CITY OF ALBUQUERQUE

RE: Office Building at 9880 Coors Blvd NW
Grading and Drainage Plan
Stamp Date: 02/08/19
Hydrology File: K14D017

Based upon the information provided in your resubmittal received 02/12/2019, the Grading and Drainage Plan cannot be approved for Building Permit until the following comments are addressed.

SHEET NUMBER:
C-102

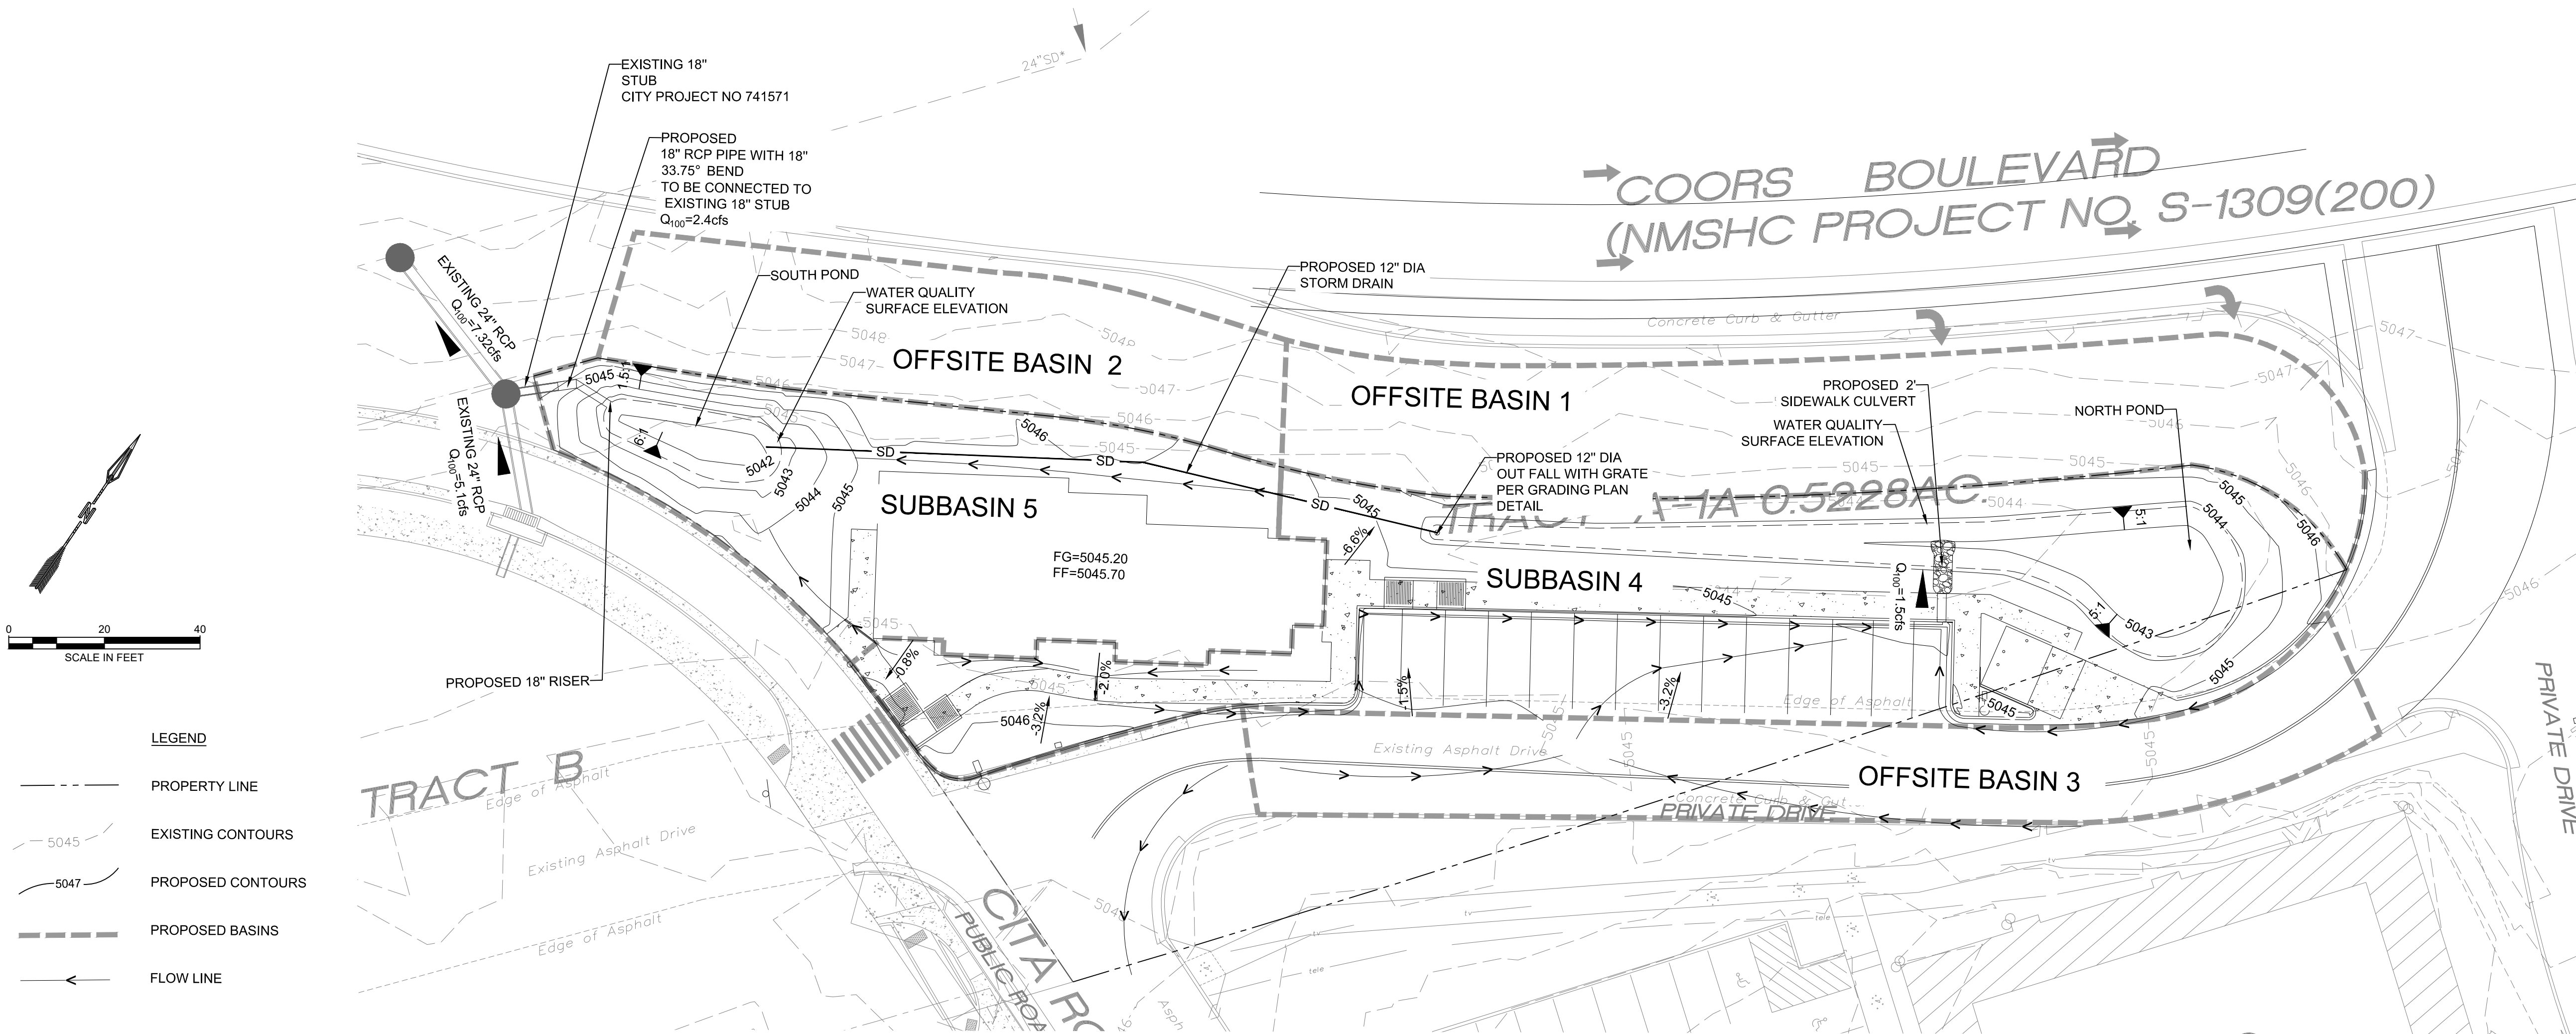
1. Please correct the Basin Numbers so that they don't change half way through the calculations. Additionally the basin labels on the map should match the calculations. Also check the references to the Basin numbers in the Proposed Conditions narrative.

2. Please provide the flow rate, velocity and capacity calculations for the onsite private storm drains.
3. Please include the detail of the outlet for the north BMP Pond on sheet C-503.

4. Weir and orifice equations should be used to check the capacity of the two pond outlet structures.
5. Please add a note next to each pond stating the SWQV required, the SWQV provided, the SWQV elevation (should be same as outlet top elevation), the 100 Year elevation, and the flow rate in the plan view of each BMP Pond so the information will be readily available when making the exhibit for the drainage covenant.
